Figure 7B-1. Signs in School Areas and at School Crossings (Sheet 1 of 2)

Summary of Comments on CAMUTCD 2026 7B Fig.pdf

Figure 7B-1. Signs in School Areas and at School Crossings ¹ (Sheet 2 of 2)

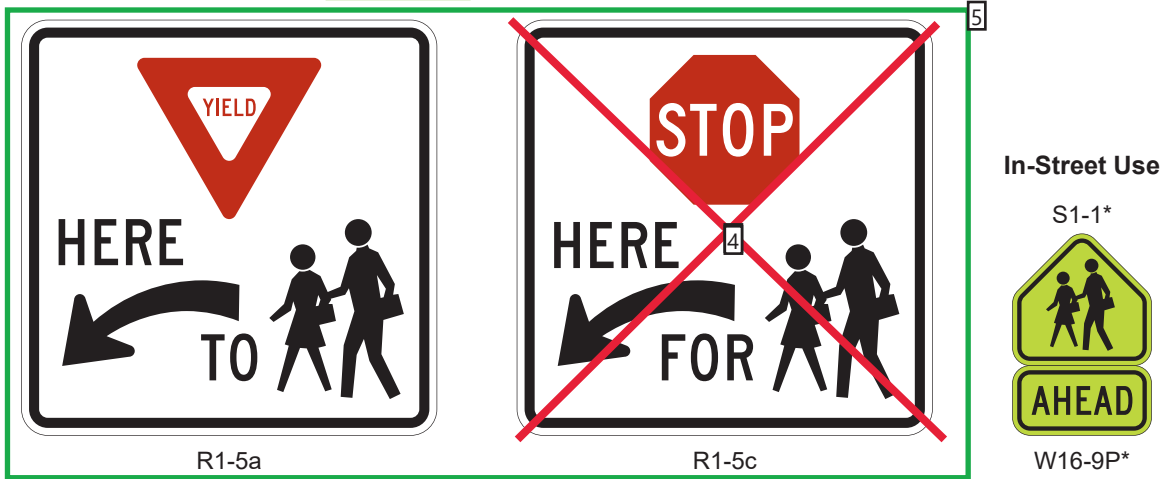
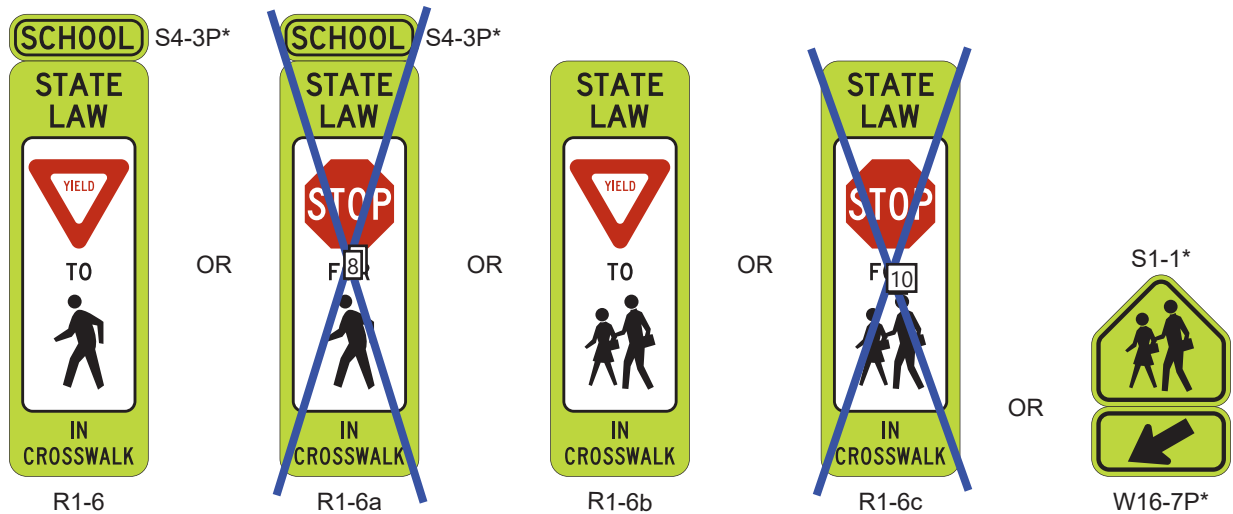
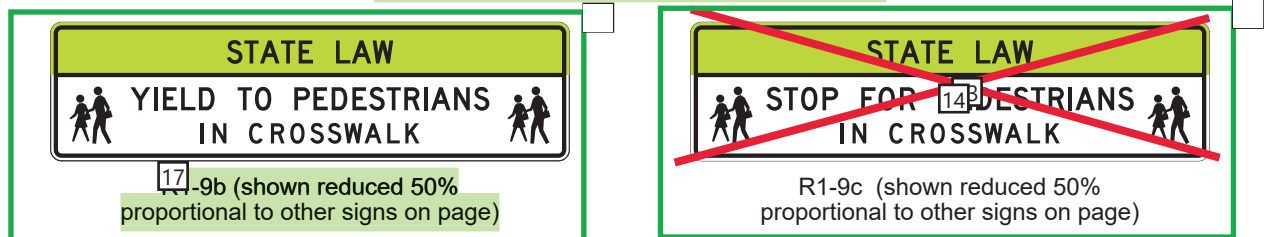
-
- Number: 1 Author: s116730 Subject: Highlight Date: 7/25/2024 9:46:47 AM
NMUTCD 2023 changed the title of Figure 7B-1 from "School Area Signs" to "Signs in School Areas and at School Crossings" and incorporated signs from NMUTCD 2009 Figures 7B-1 and 7B-6 and added sub-headings A thru D, expanding Figure 7B-1 into 2 sheets.

- Number: 2 Author: s116730 Subject: Highlight Date: 7/25/2024 9:46:51 AM
NMUTCD 2023 changed sub-heading A in NMUTCD 2009 Figure 7B-6 to B

- Number: 5 Author: s116730 Subject: Rectangle Date: 7/13/2024 10:07:09 AM
NMUTCD 2023 added new signs

- Number: 6 Author: s116730 Subject: Highlight Date: 7/25/2024 9:47:03 AM
NMUTCD 2023 changed sub-heading B in NMUTCD 2009 Figure 7B-6 to C

- Number: 11 Author: s116730 Subject: Highlight Date: 7/25/2024 9:47:07 AM
NMUTCD 2023 added sub-heading D

- Number: 15 Author: s116730 Subject: Rectangle Date: 7/13/2024 10:07:36 AM
NMUTCD 2023 added new signs

- Number: 16 Author: s116730 Subject: Rectangle Date: 7/13/2024 10:07:27 AM
NMUTCD 2023 added text "IN CROSSWALK" as 3rd line in the sign

- Number: 17 Author: s116730 Subject: Highlight Date: 7/25/2024 9:47:24 AM
NMUTCD 2023 changed sign code from R1-9 in NMUTCD 2009 to R1-9b and added this text description.

- Number: 19 Author: s116730 Subject: Highlight Date: 7/25/2024 9:47:28 AM
NMUTCD 2023 added this text in the Note #1. Note #1 previously was in NMUTCD 2009 Figure 7B-6.

- Number: 20 Author: s116730 Subject: Highlight Date: 7/25/2024 9:47:38 AM
NMUTCD 2023 added new note

Figure 7B-1(CA). Signs in School Areas and at School Crossings

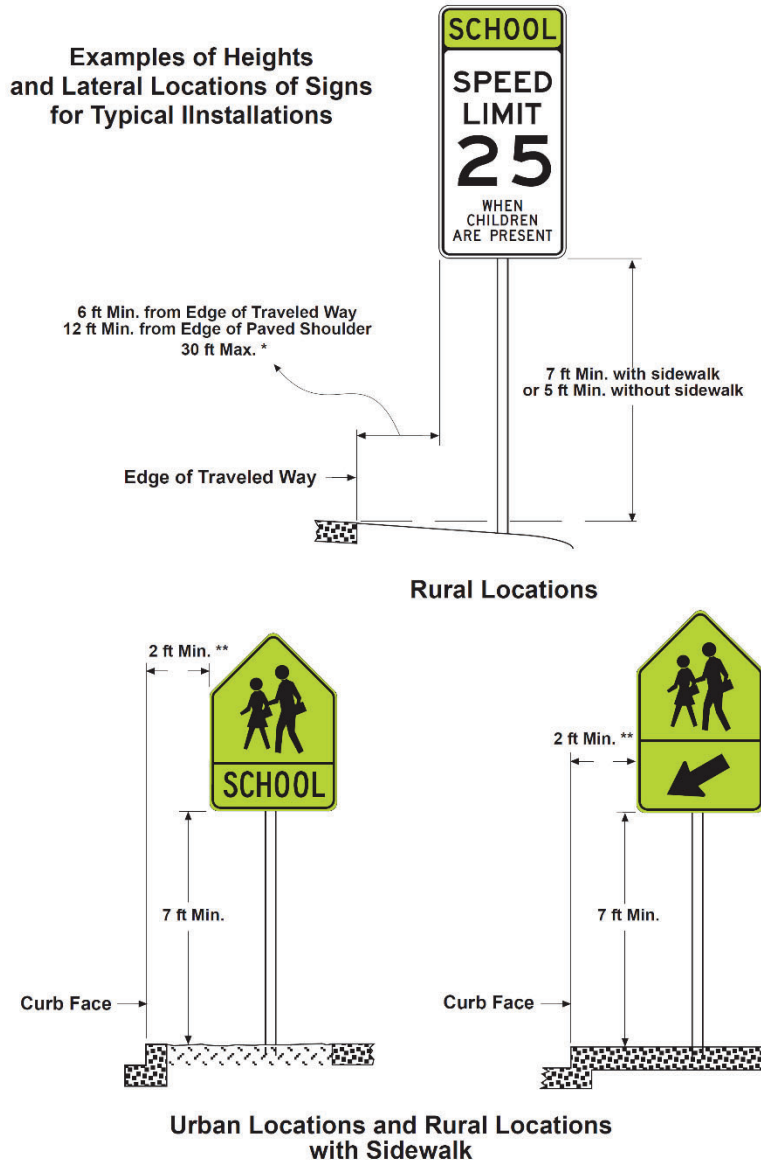
Number: 1 Author: s116730 Subject: Sticky Note Date: 7/16/2024 7:58:04 AM
Figure name changed to match NMUTCD 2023 Figure 7B-1 name and text for "(Sheet 2 of 2)" is deleted.

Number: 3 Author: s116730 Subject: Cross-Out Date: 7/25/2024 9:48:03 AM
NMUTCD 2023 changed the title of Figure 7B-1 from "School Area Signs" to "Signs in School Areas and at School Crossings"

Figure 7B-2. Example of Signing for a School Zone with a School Speed Limit and a School Crossing

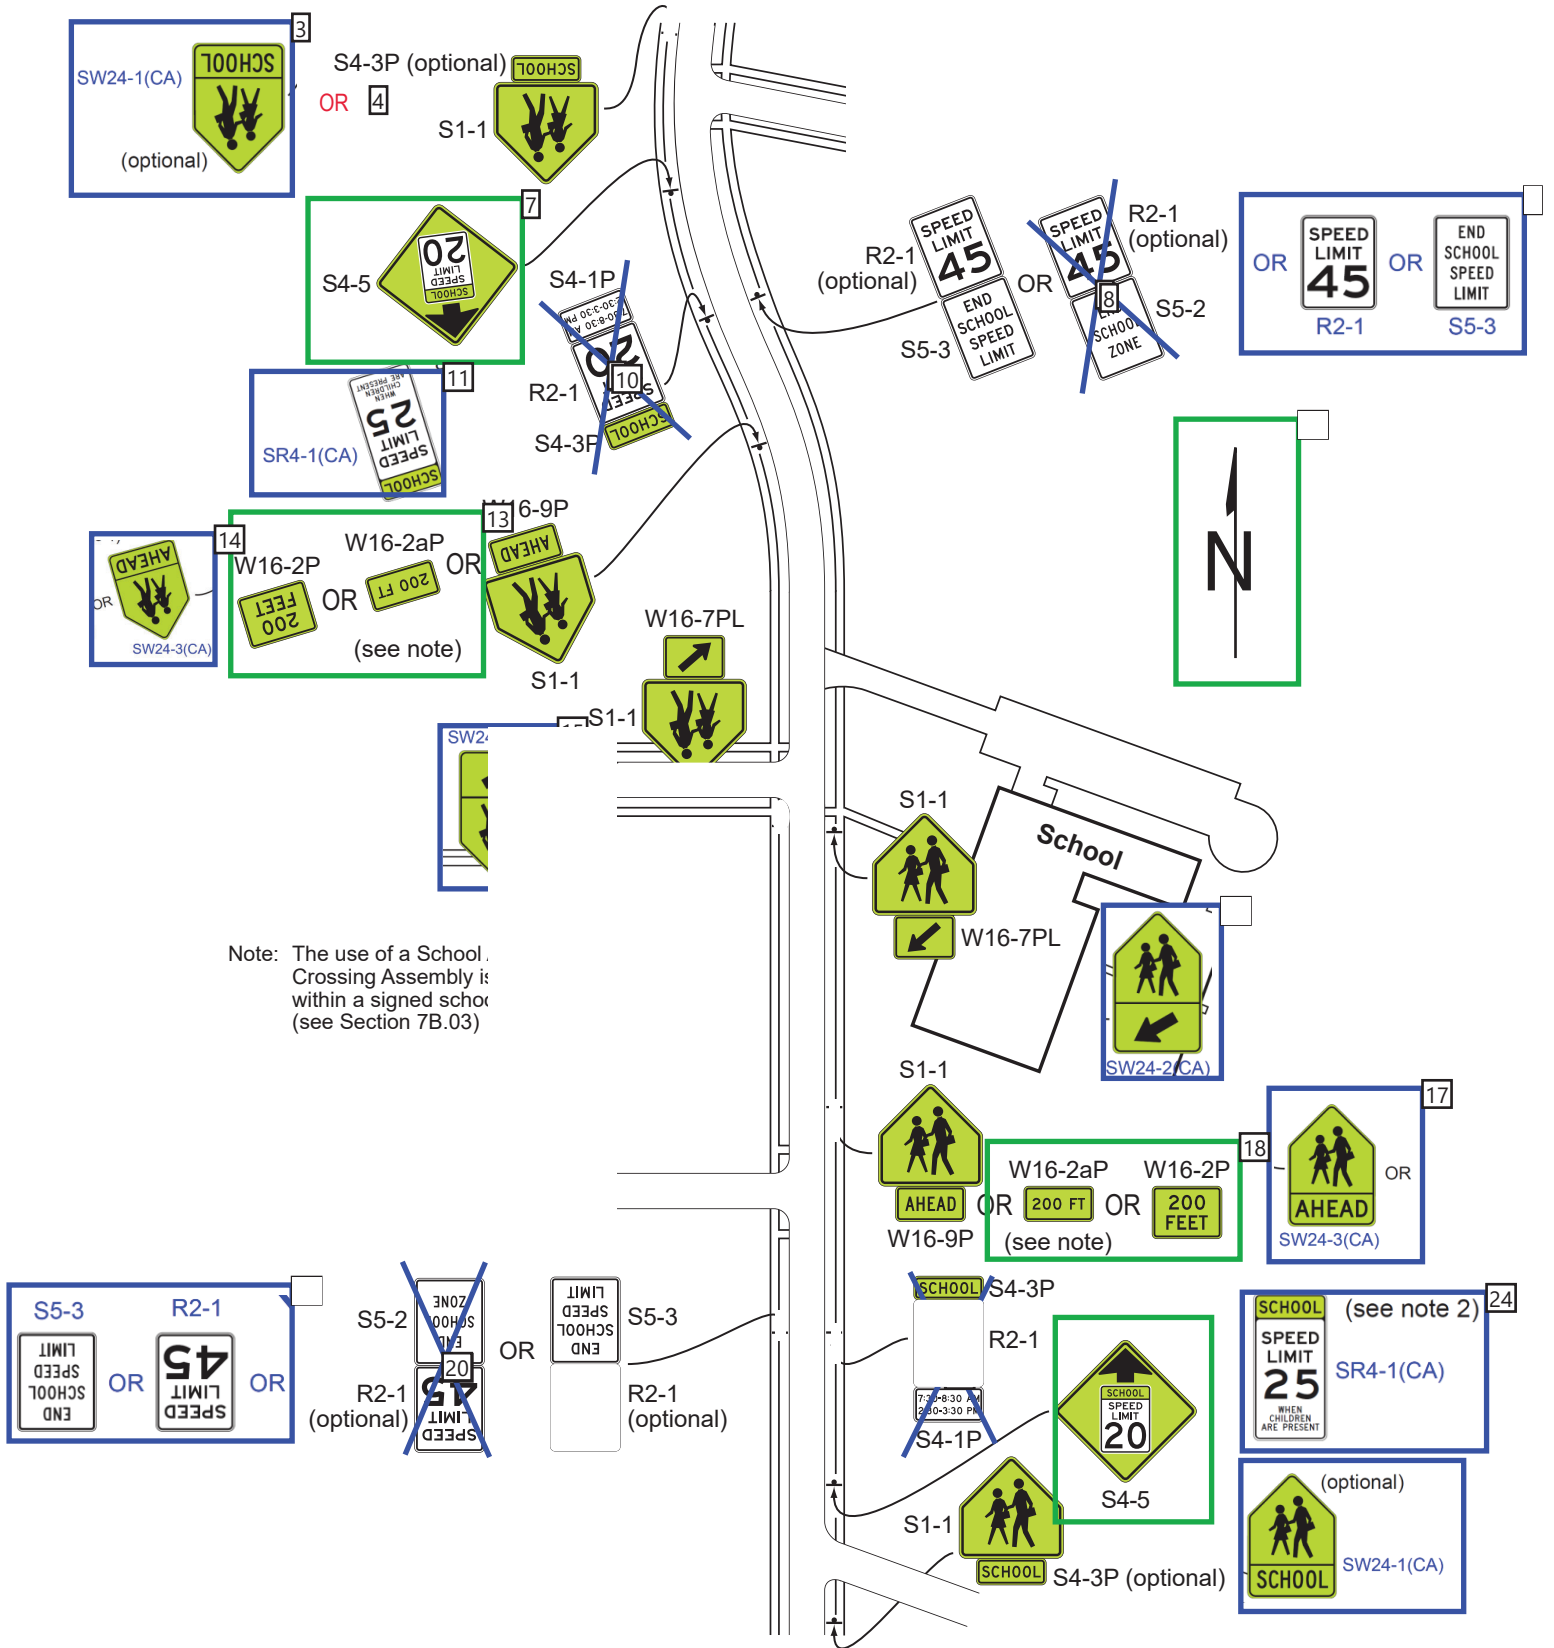
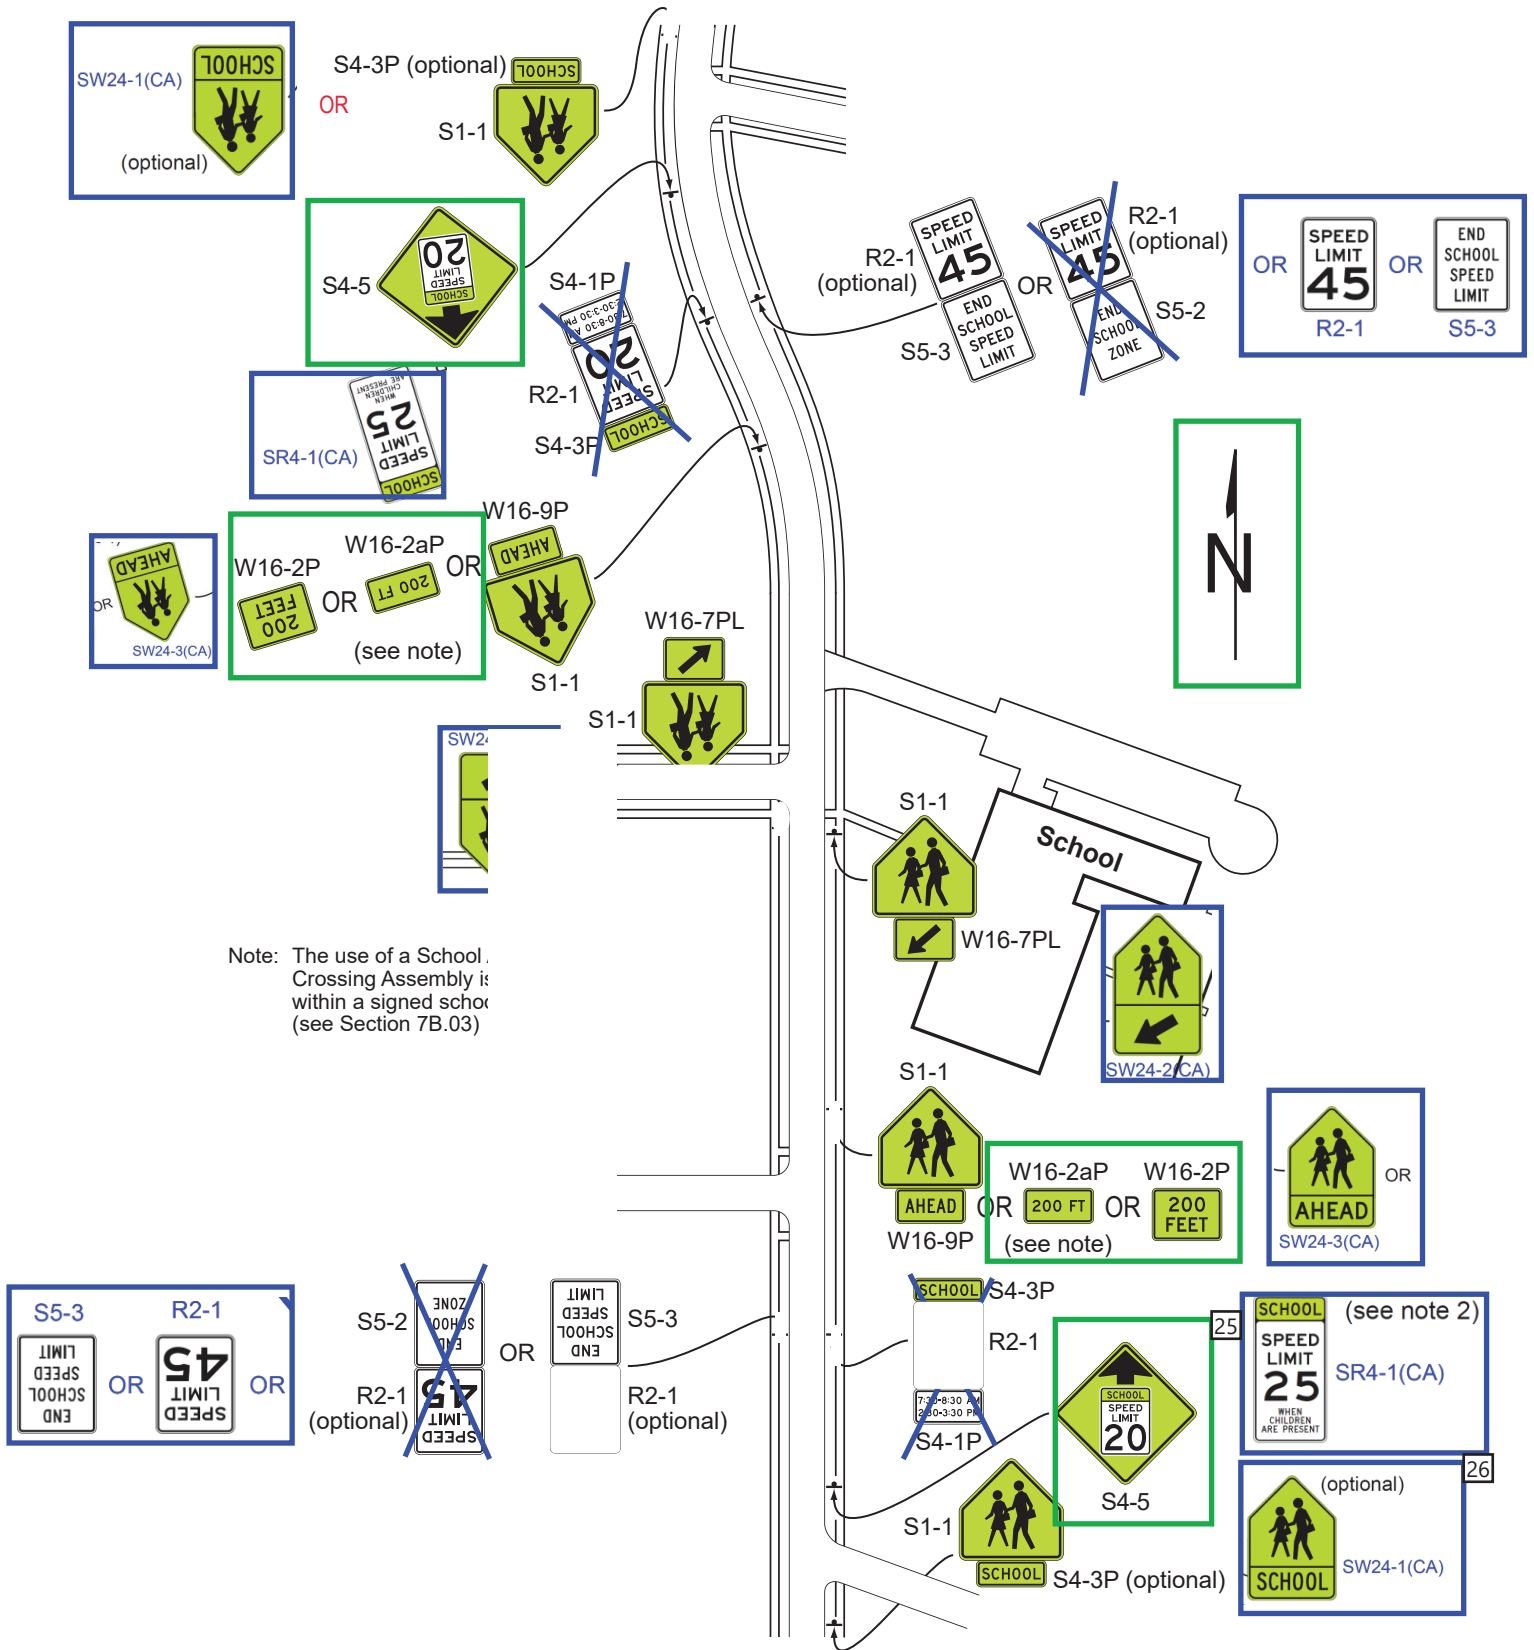
<input checked="" type="checkbox"/>	Number: 1	Author: s116730	Subject: Highlight	Date: 7/25/2024 9:48:20 AM
NMUTCD 2023 added sign codes for all signs, which were missing in NMUTCD 2009 figures				
<input checked="" type="checkbox"/>	Number: 2	Author: s116730	Subject: Highlight	Date: 7/25/2024 9:48:24 AM
NMUTCD 2023 changed NMUTCD 2009 Figure 7B-5 to 7B-2 and added sign codes for the signs shown in the figure.				
<input type="checkbox"/>	Number: 3	Author: s116730	Subject: Rectangle	Date: 7/10/2024 9:45:30 AM
Incorporated from CA MUTCD 2014R8 Figure 7B-5				
<input type="checkbox"/>	Number: 4	Author: s116730	Subject: Text Box	Date: 7/10/2024 9:43:42 AM
OR				
<input checked="" type="checkbox"/>	Number: 5	Author: s116730	Subject: Line	Date: 7/10/2024 9:37:58 AM
<input type="checkbox"/>	Number: 6	Author: s116730	Subject: Rectangle	Date: 7/10/2024 9:55:06 AM
Incorporated from CA MUTCD 2014R8 Figure 7B-5

<input type="checkbox"/>	Number: 7	Author: s116730	Subject: Rectangle	Date: 7/14/2024 8:38:40 AM
NMUTCD 2023 added new sign				
<input checked="" type="checkbox"/>	Number: 8	Author: s116730	Subject: Line	Date: 7/10/2024 9:37:47 AM
<input checked="" type="checkbox"/>	Number: 9	Author: s116730	Subject: Line	Date: 7/10/2024 9:38:20 AM
<input checked="" type="checkbox"/>	Number: 10	Author: s116730	Subject: Line	Date: 7/10/2024 9:38:20 AM
<input type="checkbox"/>	Number: 11	Author: s116730	Subject: Rectangle	Date: 7/10/2024 9:55:55 AM
Incorporated from CA MUTCD 2014R8 Figure 7B-5				
<input type="checkbox"/>	Number: 12	Author: s116730	Subject: Rectangle	Date: 7/14/2024 8:40:44 AM
NMUTCD 2023 added new cardinal direction "N" arrow				
<input type="checkbox"/>	Number: 13	Author: s116730	Subject: Rectangle	Date: 7/13/2024 10:10:07 AM
NMUTCD 2023 added new plaques				
<input type="checkbox"/>	Number: 14	Author: s116730	Subject: Rectangle	Date: 7/10/2024 2:53:25 PM

Incorporated from CA MUTCD 2014R8 Figure 7B-5				
<input type="checkbox"/>	Number: 15	Author: s116730	Subject: Rectangle	Date: 7/10/2024 2:34:53 PM
Incorporated from CA MUTCD 2014R8 Figure 7B-5				
<input type="checkbox"/>	Number: 16	Author: s116730	Subject: Rectangle	Date: 7/10/2024 2:35:20 PM
Incorporated from CA MUTCD 2014R8 Figure 7B-5				
<input type="checkbox"/>	Number: 17	Author: s116730	Subject: Rectangle	Date: 7/10/2024 9:56:34 AM
Incorporated from CA MUTCD 2014R8 Figure 7B-5				
<input type="checkbox"/>	Number: 18	Author: s116730	Subject: Rectangle	Date: 7/13/2024 10:10:21 AM
NMUTCD 2023 added new plaques				
<input checked="" type="checkbox"/>	Number: 19	Author: s116730	Subject: Line	Date: 7/10/2024 9:51:04 AM
<input checked="" type="checkbox"/>	Number: 20	Author: s116730	Subject: Line	Date: 7/10/2024 9:50:49 AM
<input checked="" type="checkbox"/>	Number: 21	Author: s116730	Subject: Line	Date: 7/10/2024 9:40:05 AM

Number: 25 Author: s116730 Subject: Rectangle Date: 7/13/2024 10:10:35 AM
NMUTCD 2023 added new sign

Number: 26 Author: s116730 Subject: Rectangle Date: 7/10/2024 9:56:45 AM
Incorporated from CA MUTCD 2014R8 Figure 7B-5

Figure 7B-2(CA) Example of Signage for a School Zone with a School Speed Limit and a School Crossing

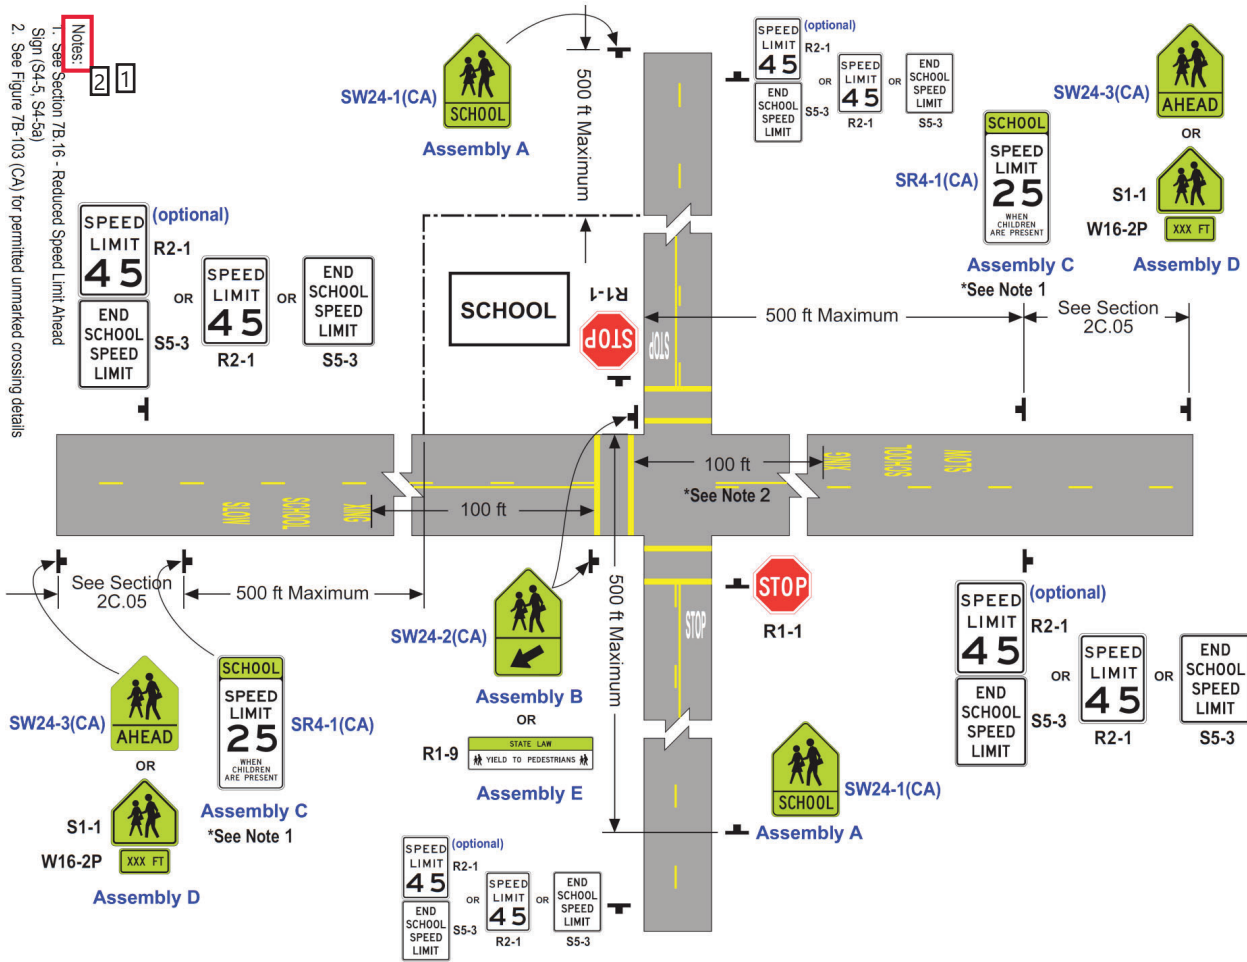
Add new note:

3. See Section 7B.02 for Assembly A(CA), Section 7B.03 for Assemblies B(CA), D(CA) and E(CA), and Section 7B.05 for Assembly C.

NMUTCD 2023 changed NMUTCD 2009 Figure 7B-5 to 7B-2. This figure is renumbered as 7B-2(CA) and is included in CA MUTCD 2026
